Addendum #4
Southern Wells Community Schools
Raiders Activity Center and Raider Dome Lockers

Date: April 03, 2026
Project: Southern Wells Community Schools Raiders Activity Center and Raider Dome Lockers
Project #: 25048
Pages: 1 of 5 (8-1/2x11) pages
Bid Dates: THURSDAY, April 9, 2026 at 4:00 pm (prevailing local time)

The original Specifications and Drawings dated April 03, 2026 for the project referenced above are amended as noted in this Addendum No. 4. Receipt of this Addendum and any subsequent Addenda must be acknowledged on the Bid Form. Items changed or added by this addendum are to take precedence over the items or descriptions of the work in the project manual and the drawings. Items not mentioned in this addendum are to remain as described in the original plans and specifications.

**SITE DEMOLITION PLAN**
1" = 20'

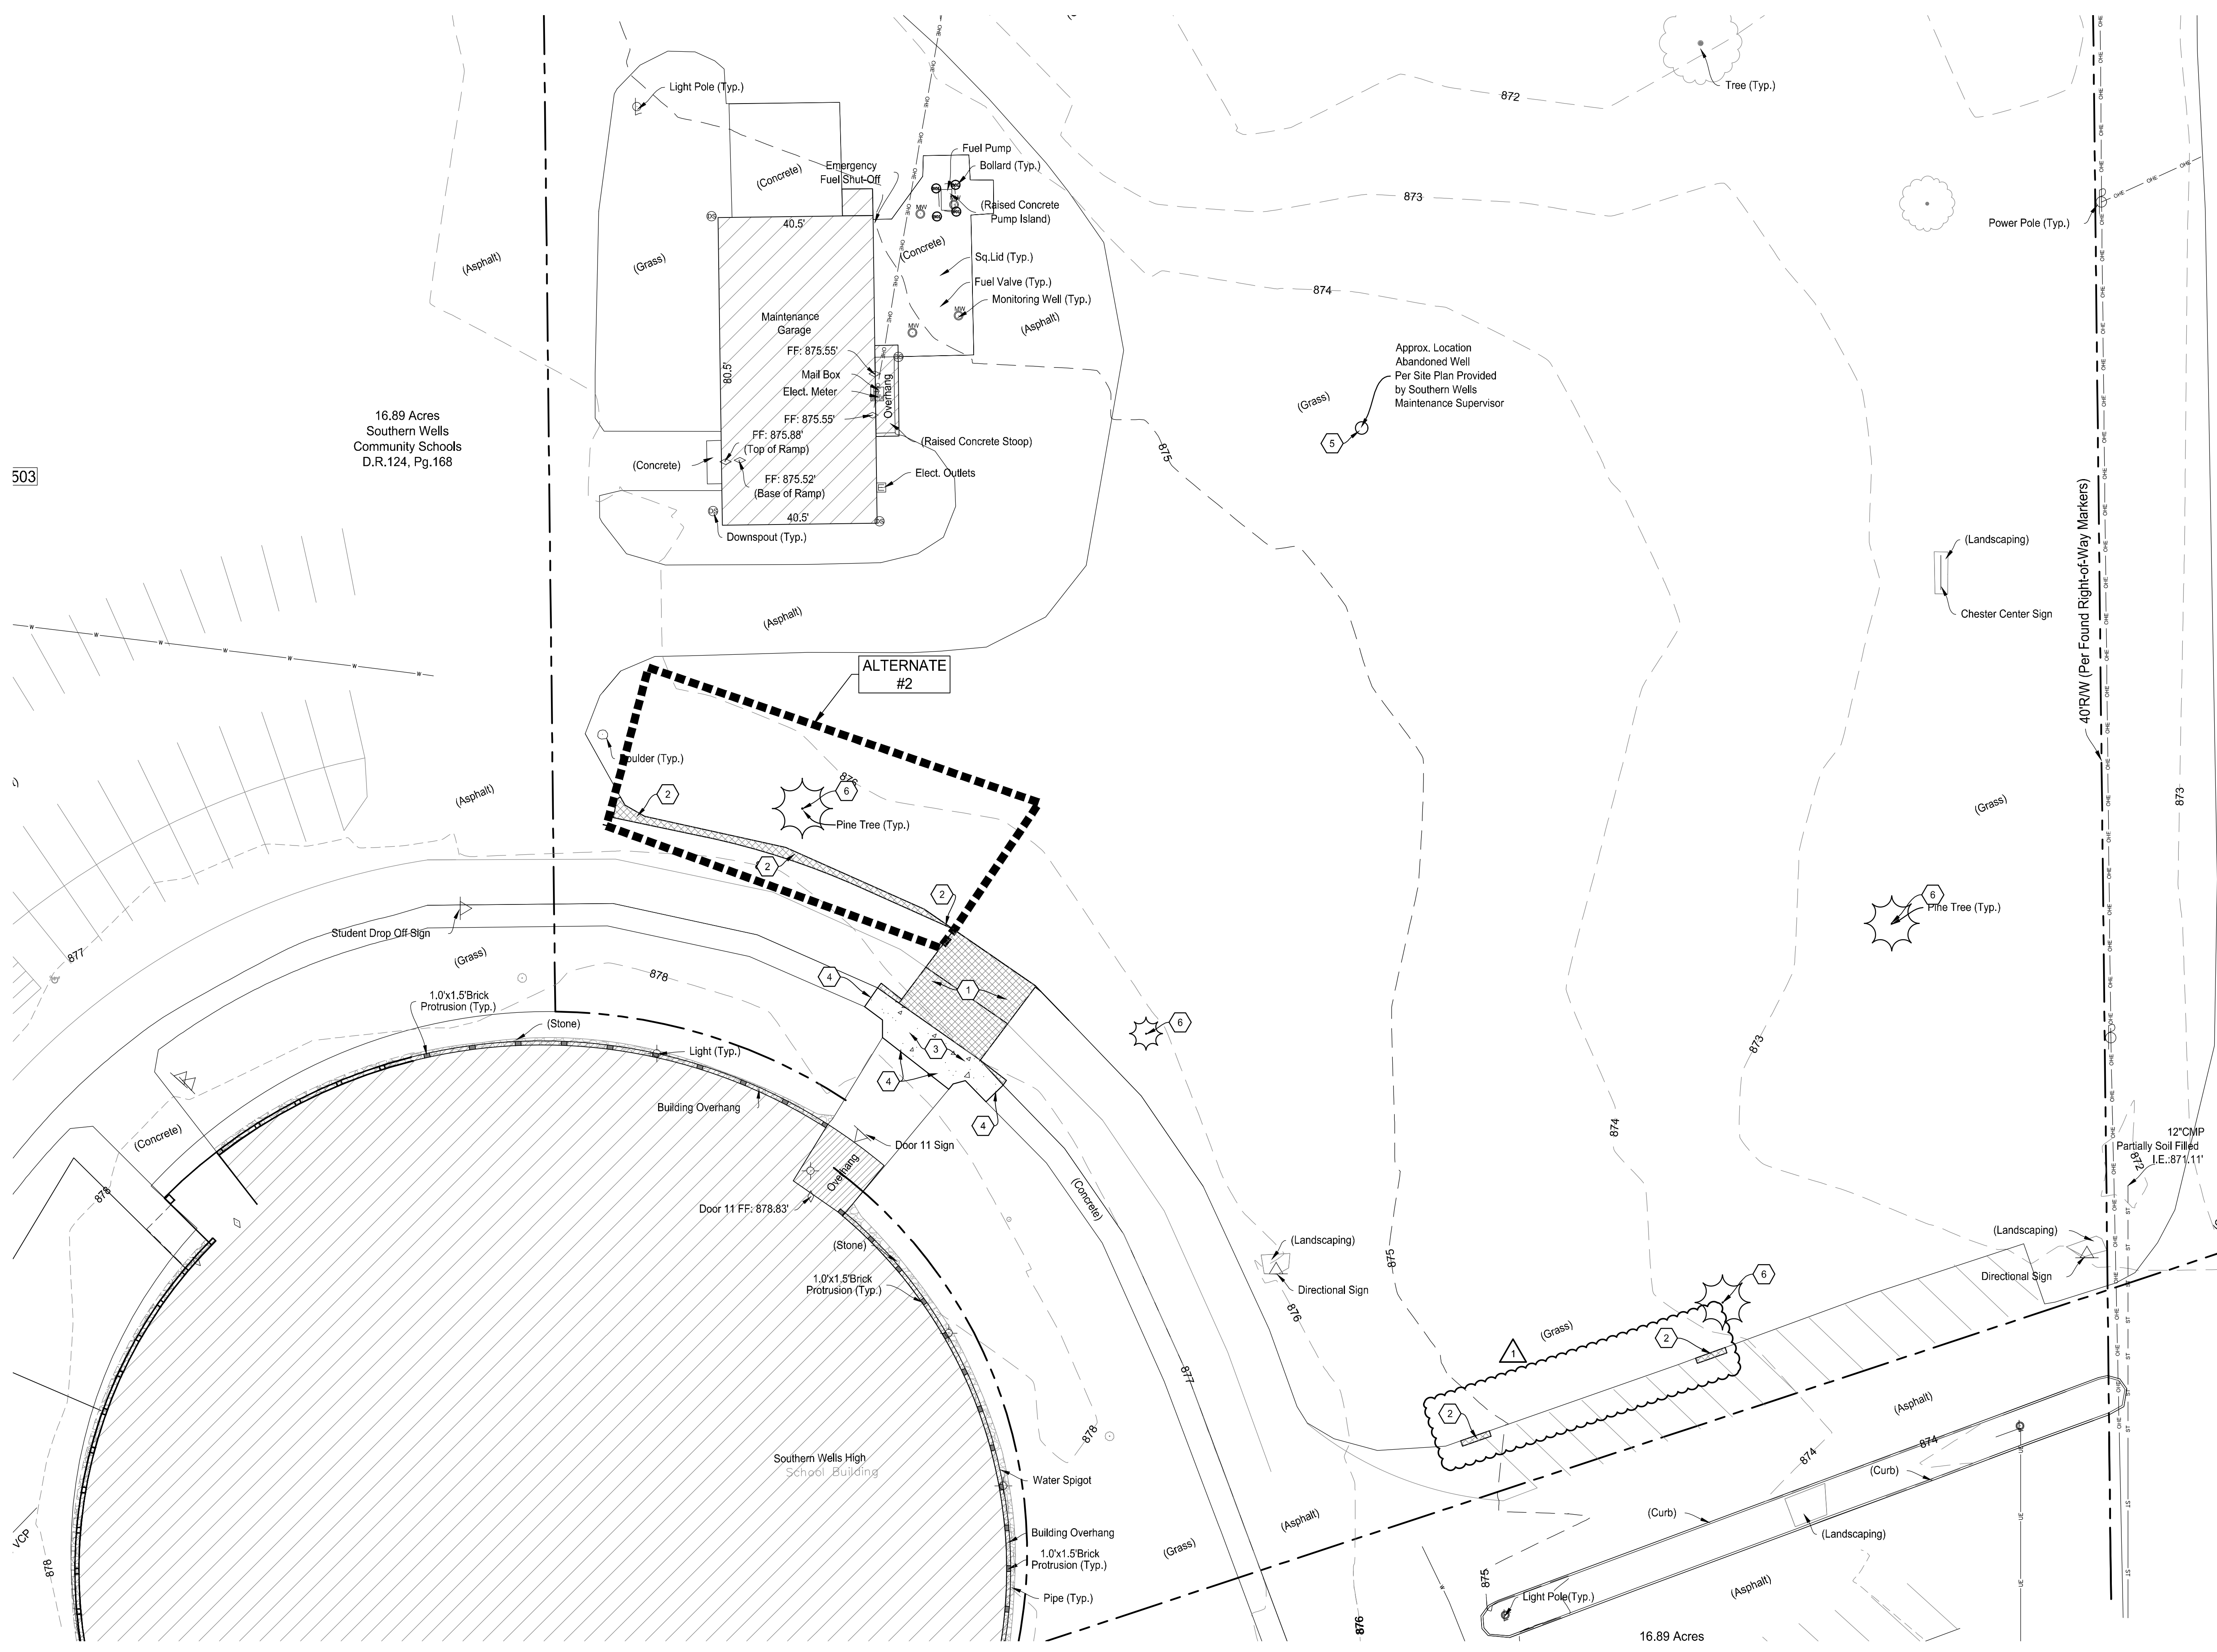
10. Q: C1.0 indicates to remove the abandoned well that we were told not to carry cost to remove/seal during the pre-bid walk. Please confirm.
 - a. **Please see the attached C1-0 sheet. The Contractor is not responsible for removing or sealing the well at this time (not to be included in the bid). The earthwork contractor shall verify that the existing well has been properly sealed and abandoned and report any discrepancies from anticipated conditions to the design team.**

SITE UTILITY PLAN
 SCALE: 1" = 20'
 NORTH

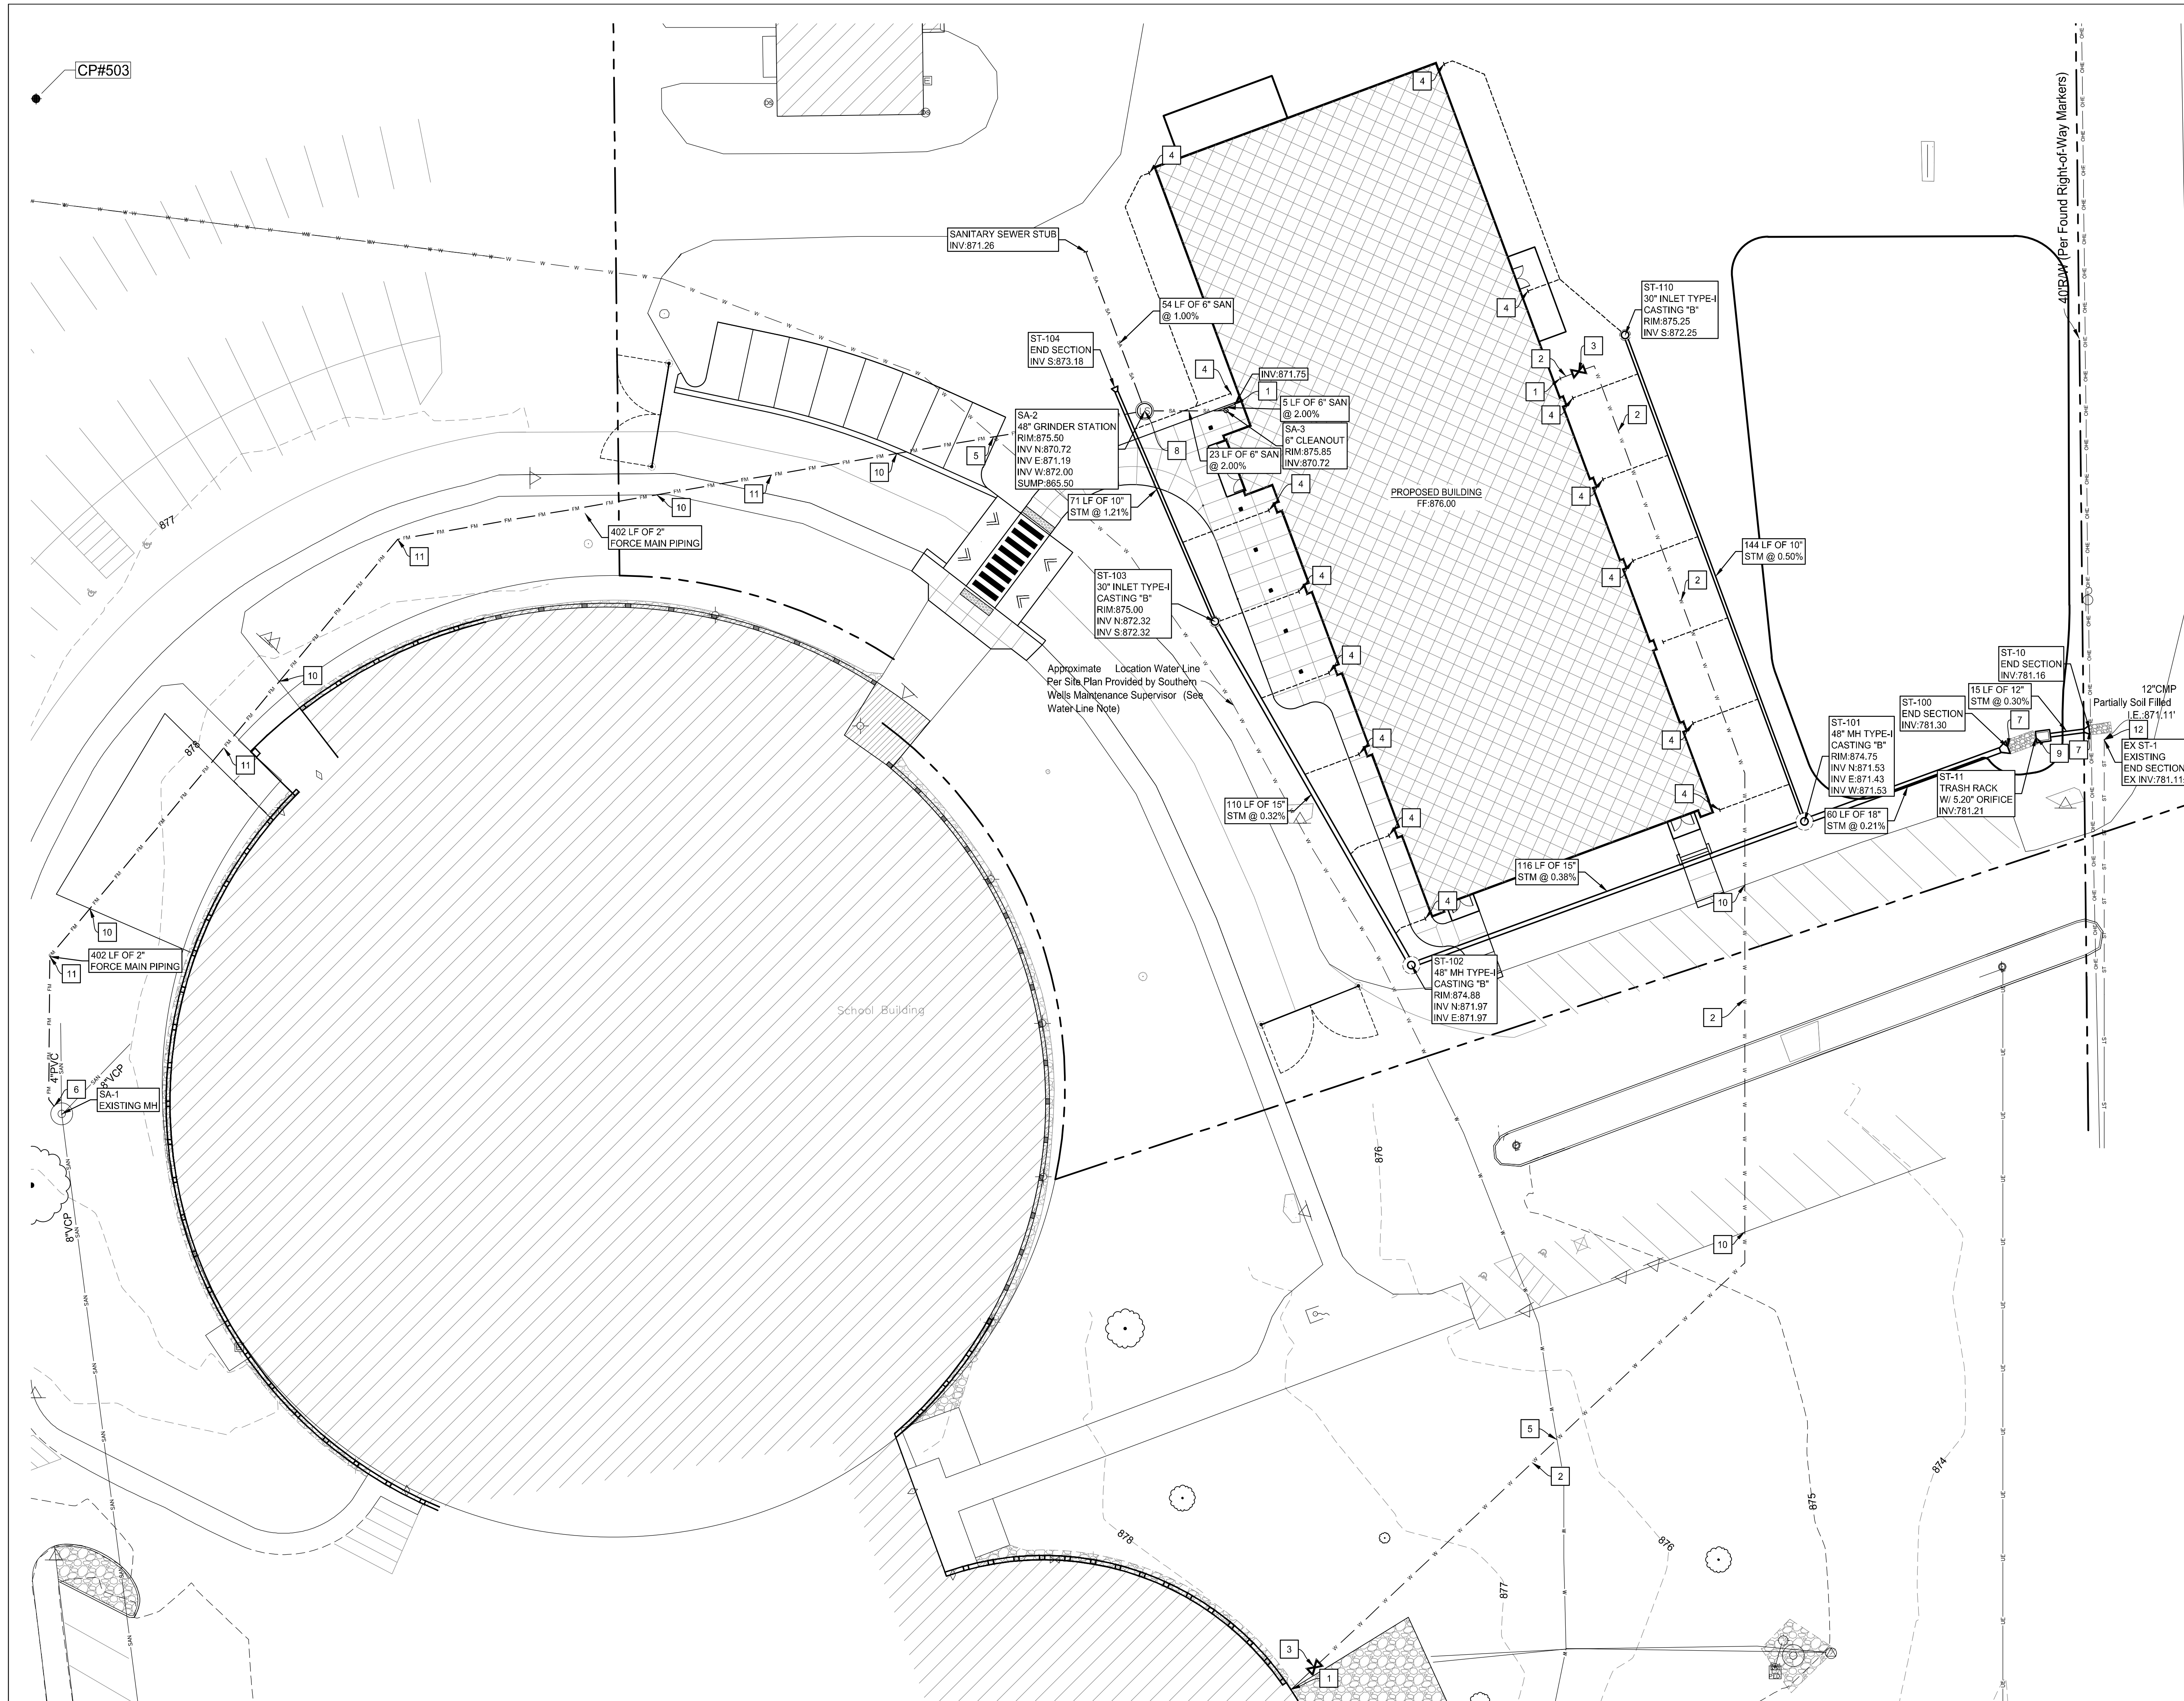
4. Q: C4.0 Utility note 9 references a detail #8 that does not exist on C6.1.
 - a. **Trash rack detail is provided as 9/C6.2**
5. Q: Is there a Geotech report that we can review prior to bidding?

Sheet C4-0 SITE UTILITY PLAN

1. *Change note 2 to “2” WATER LINE.”*
2. *Change note 3 to “2” CURB STOP AND BOX.”*
